UNITED STATES PATENT AND TRADEMARK OFFICE

APPLICATION NO.	FILING DATE	FIRST NAMED INVENTOR	ATTORNEY DOCKET NO.	CONFIRMATION NO.
09/609,868	07/03/2000	Kenneth Gordon Walker	W2450002	3798

Office Action Summary

DETAILED ACTION

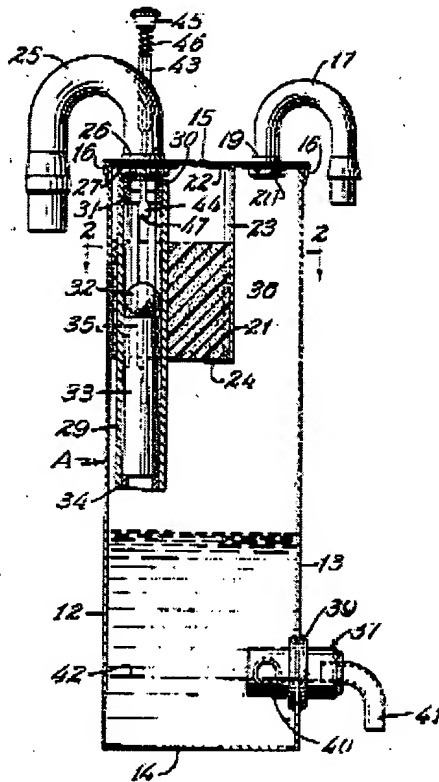
Claims 29, 31, 33 and 36 are rejected under 35 U.S.C. § 102(e) as being anticipated by *Beguiristain* (U.S. Pat. No. 3,612,089).

As to claim 29, *Beguiristain* teaches a lid (15) covering a canister body (12)(13) together forming a canister for receiving fluids, said canister body (12)(13) having side walls and a bottom, said lid (15) comprising:

An inlet port (20) in said lid (15) for inflow of fluids into said canister;

An outlet port (30) in said lid (15) for outflow of fluids from said canister;

A conduit (29) in fluid communication with said outlet port (30), said conduit (29) extending to said bottom of said canister body when said lid (15) is placed in covering relation to said canister body (*see* Fig. 1, below).

As to claim 31, *Beguiristain* teaches a vacuum port (30)(col. 2, lines 26-36).

As to claim 33, *Beguiristain* teaches a check valve (32).

As to claim 36, *Beguiristain* teaches a bottom wall (14).
